THE CITY OF SPRUCE GROVE

BYLAW C-1066-19

East Pioneer Area Structure Plan Amendment

AREA STRUCTURE PLAN AMENDMENT

FIGURE 5

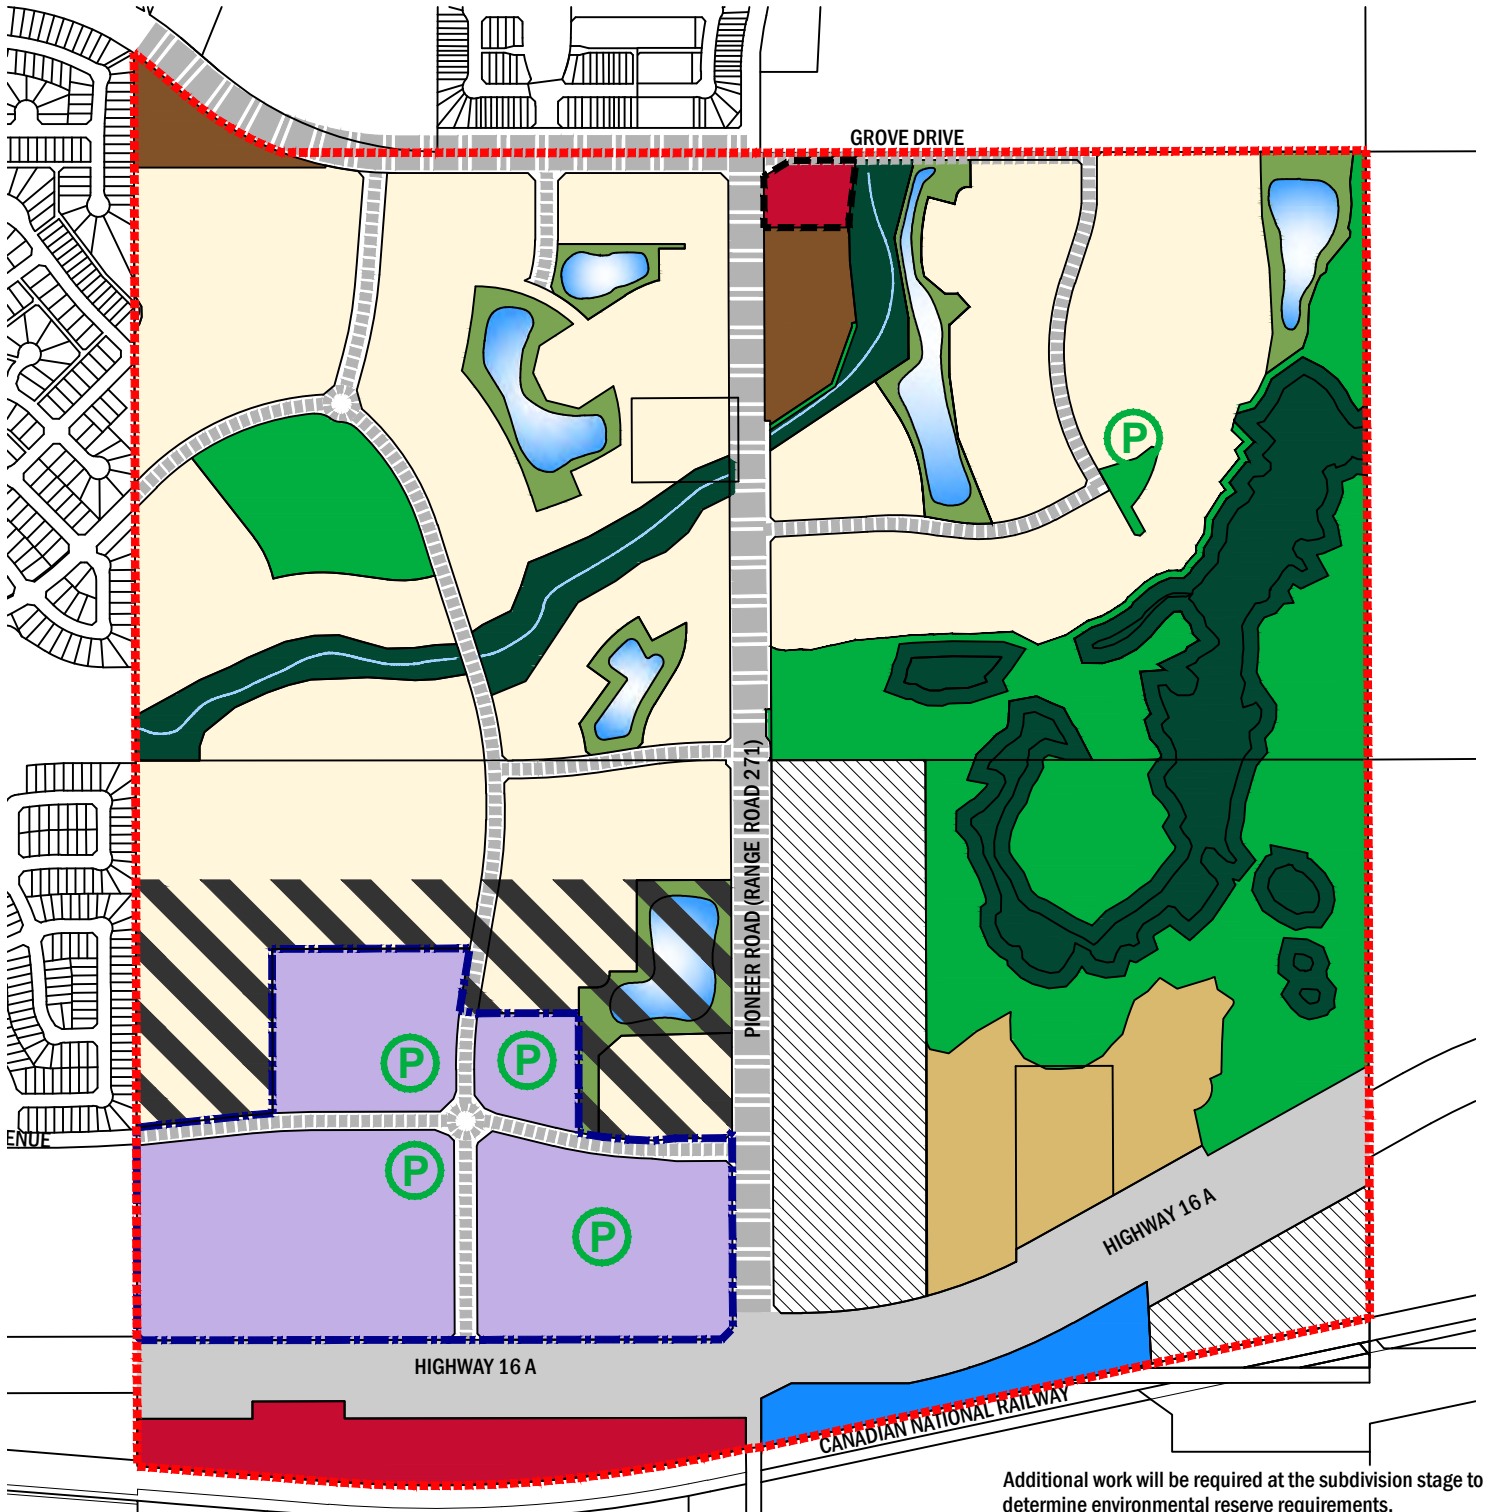
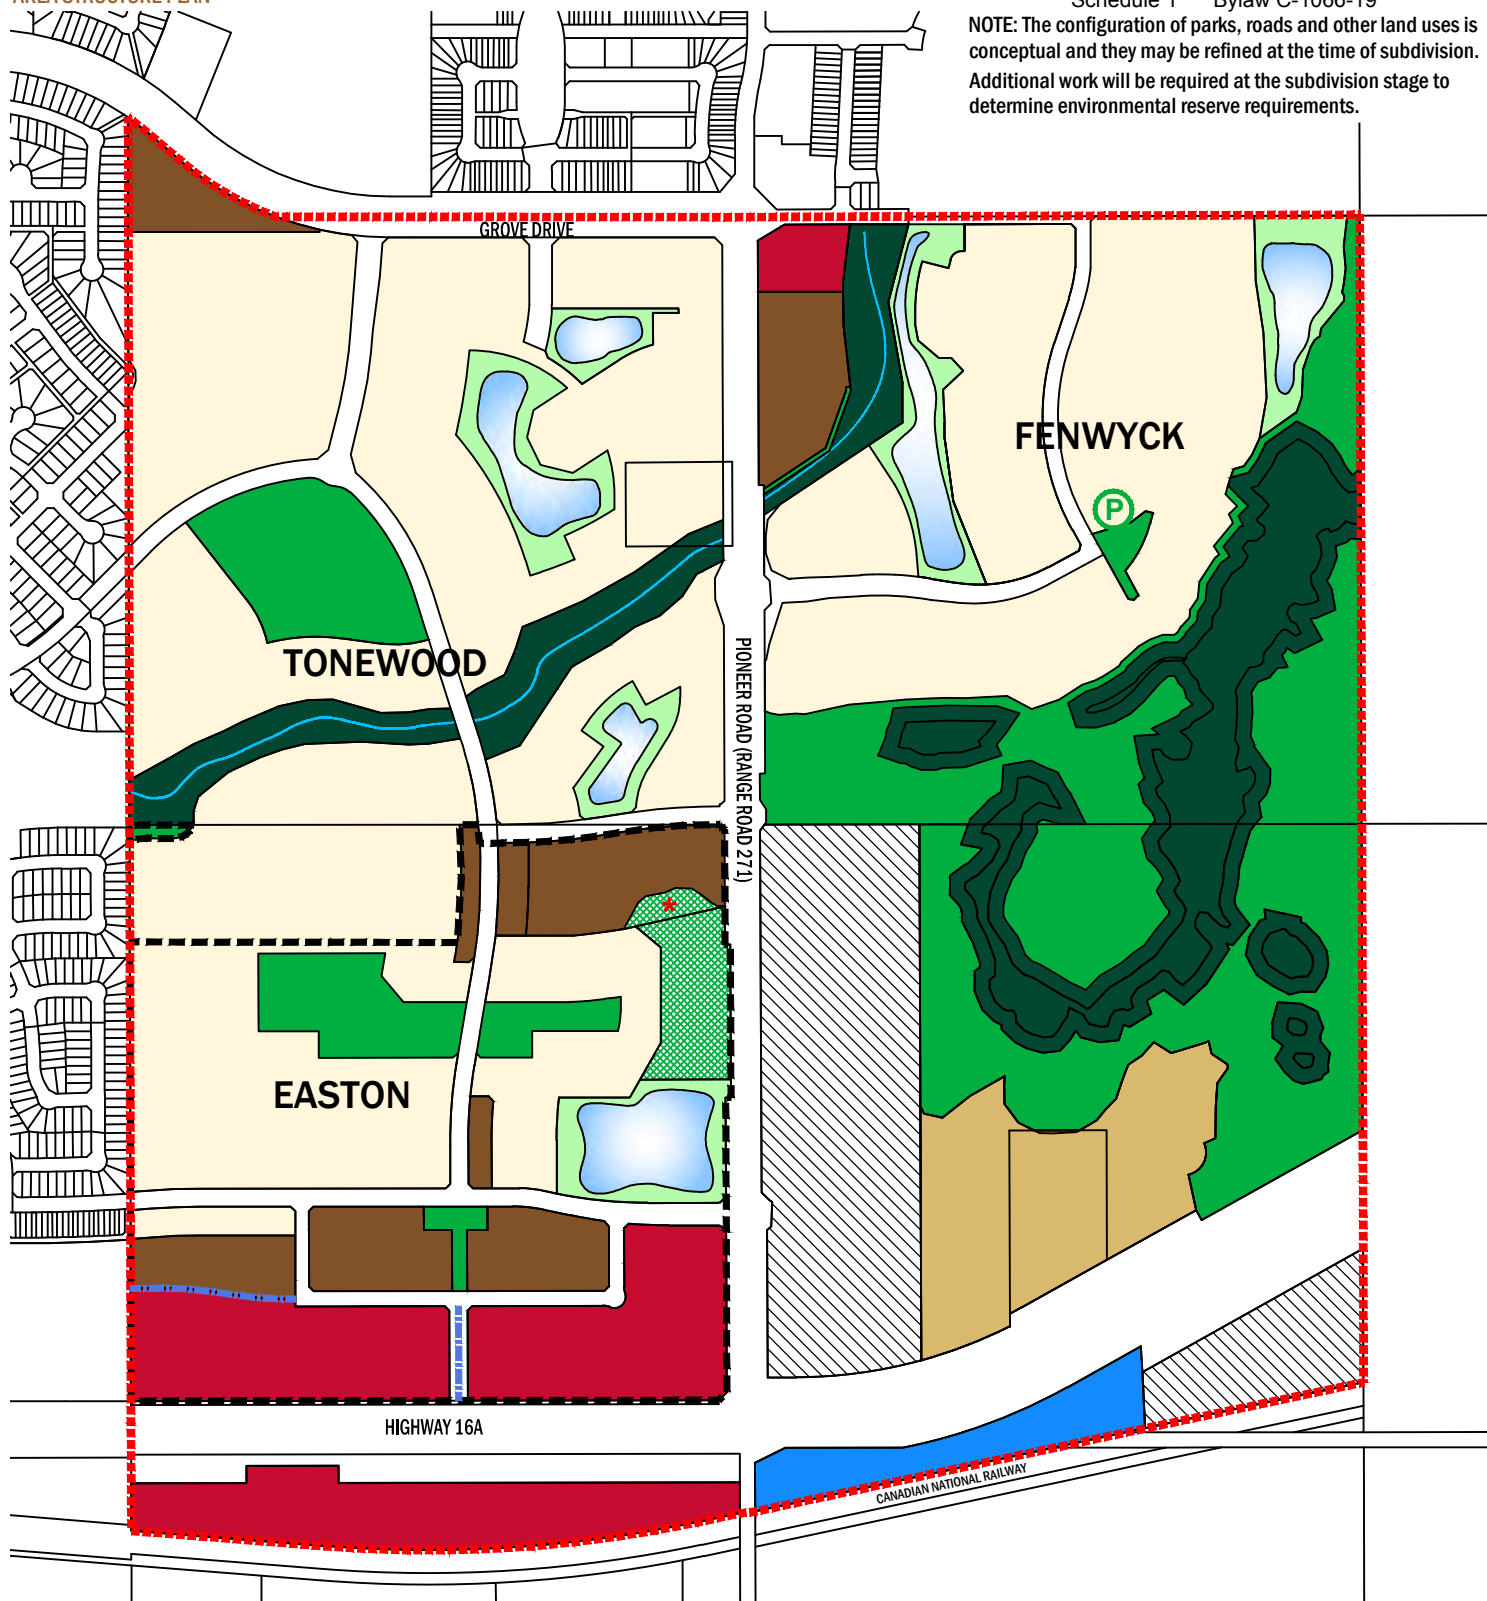
- Add residential, commercial and municipal reserve park spaces to the Easton Neighbourhood,
- Remove the Urban Village Land Use and the Urban Village Influence from Figure 5, and replace with defined locations for residential, commercial and park/open space land uses,

The Urban Village land use measuring 26.6 ha has been removed from the East Pioneer ASP. All references to the Urban Village, including but not limited to Section 4.4.8, are deleted and the Urban Village Centre Mixed Use and Urban Village Influence land use designations are removed from the Land Use Concept in Figure 5 and the Land Uses Statistics in Table 2.

As shown in the proposed Land Use Concept (Figure 5), a 3.34 ha Medium to High Density Residential land use is added to the northeast corner of Easton adjacent to Pioneer Road with access from the collector road to the north. An additional 5.52 ha Medium to High Density Residential area is added south of McLeod Avenue adjacent to the commercial sites. 0.83 ha of Medium to High Density Residential has also been added along the north/south collector road. Street-oriented row housing can be developed under either the R1 or R2 district.

An 11.37 ha commercial area is located immediately north of Highway 16A, replacing the Mixed Use Commercial/Employment component that was planned within the Urban Village.

Easton is proposed to increase to 4.33 ha. These changes, and the removal of the symbols for potential park/open space locations from the amendment area, are illustrated on Figures 5 and 6. In addition to the new parks, the Active Network & Open Space Plan (Figure 6) has been updated to identify Pedestrian Walkway locations required for connectivity and to optimize use and awareness of the off-street trail network.

FIGURE 6

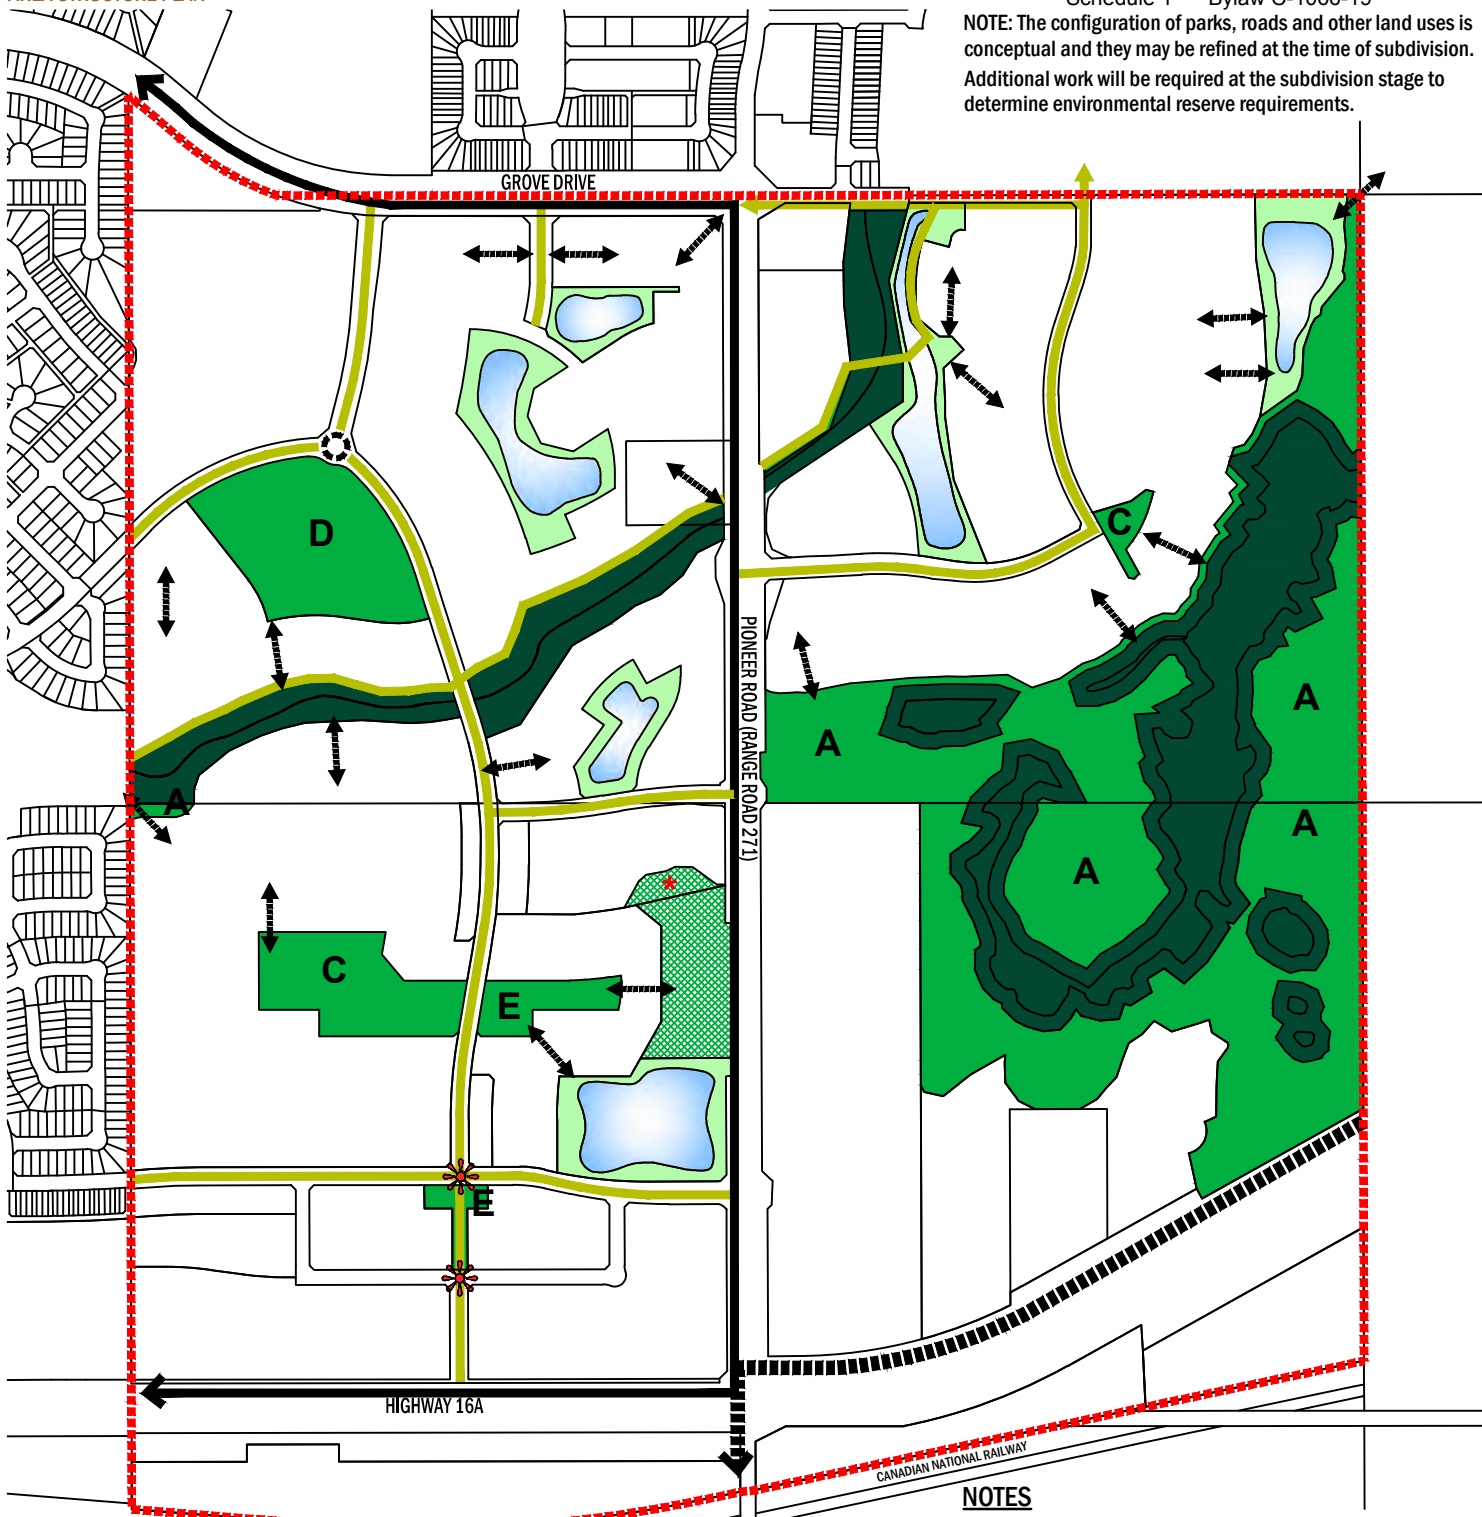
A priority pedestrian crossing is proposed at the north end of the linear park and is depicted by a star symbol on Figure 6. This intersection was designated as a "key pedestrian crossing" (focal point) in the original ASP due to the crossing of two major collector roadways at the entrance to the Urban Village concept contemplated at the time. Although this intersection

FIGURE 7

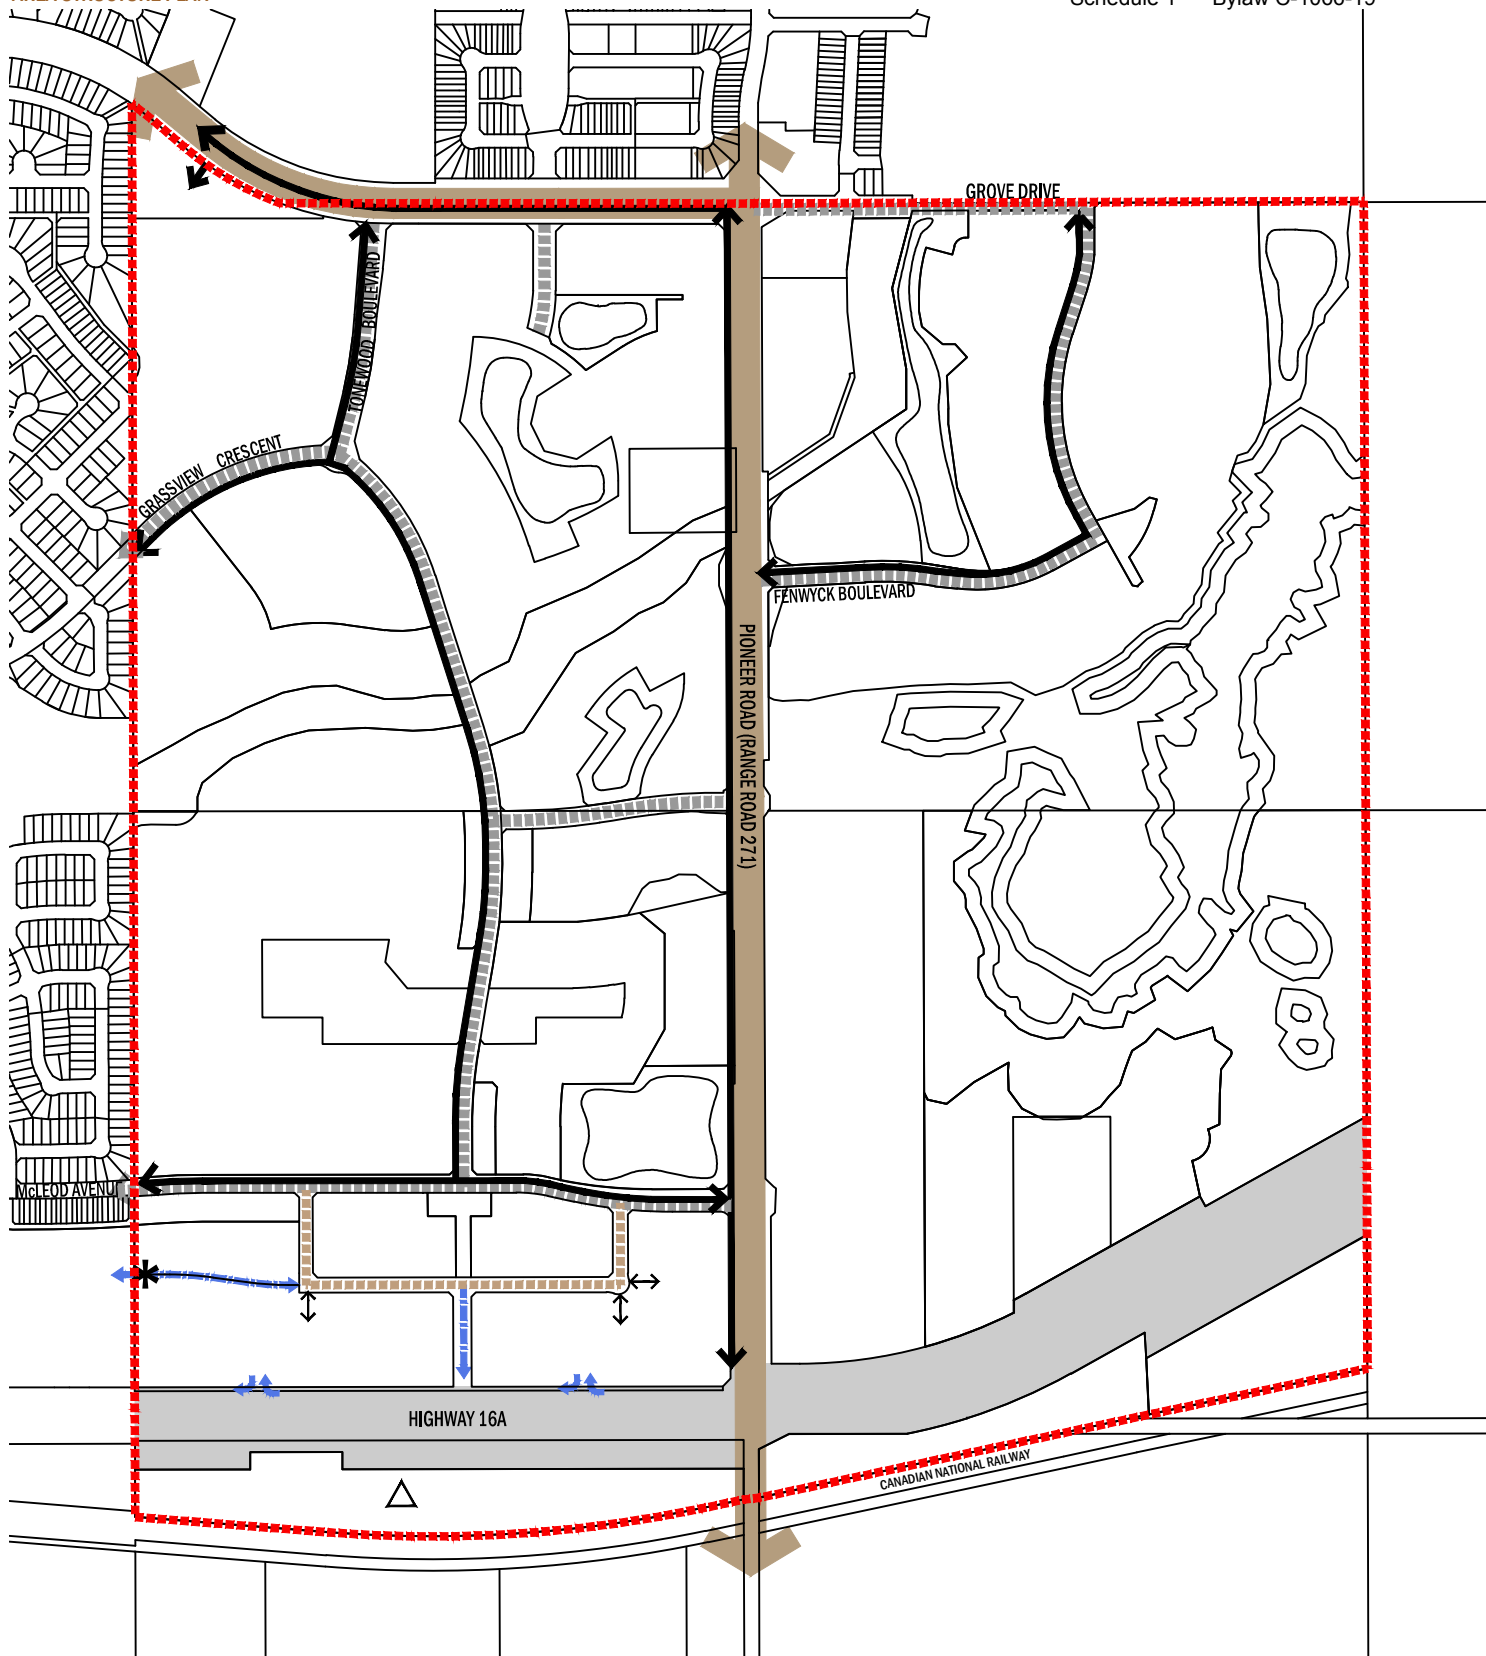
- Remove a 2.0 ha Urban Village Park from the land use statistics and add park spaces to the land use concept,
- Add potential commercial access locations from Highway 16A to Figure 7,

- Remove the symbol for Transit Centre from Figure 7 and
- Add a reference table and graphic that summarizes the findings of each study required to support development within the ASP, including the fen and peat lands as Appendix A.

The collector roadways in the southern central area of the Easton neighbourhood have been adjusted, as illustrated in Figure 7, due to the removal of the Urban Village. The major changes include:

- The removal of a portion of the north/south collector road that connected Highway 16A to the future extension of McLeod Avenue.
- A collector loop south of future McLeod Avenue (with two connecting intersections with future McLeod Avenue) will provide access to both the Medium to High Density Residential areas and the north side of the commercial area. This road provides a key transition between the Easton commercial uses and residential uses. Alternative road cross-sections designed to specifically assist in this transition, and maintain functionality for user groups and the various modes of transportation may be considered at the time of subdivision. The right angle turns shown in this loop offer excellent intersection locations for potential access into the commercial area and have been identified as such on Figure 7.

for the area based on commercial types, traffic projections, and potential parking restrictions. Vehicle access locations from Highway 16A into the commercial area are identified and are shown on Figure 7.

The location of key pedestrian walkways has been updated for the Easton neighbourhood and is illustrated on Figure 7. A circular symbol indicating a “key pedestrian crossing (focal point)”, at the intersection of McLeod Avenue and the proposed linear park, has been replaced by a star to indicate an important intersection for active travelers accessing the park and the linear walkway that leads to the commercial area. Although it was never defined, as such, within the ASP text, the circle symbol may have set an expectation for a roundabout at this location. A roundabout remains an option, but the specific traffic control at this location shall be determined at time of subdivision. An additional priority pedestrian crossing has been added on the south end of the linear park.

A transit node was originally contemplated within the Urban Village to service the future mixed-use destination. With the removal of the Urban Village, and revised City transit planning, this transit node is no longer required. The location of the potential transit node has been removed from Figure 7.
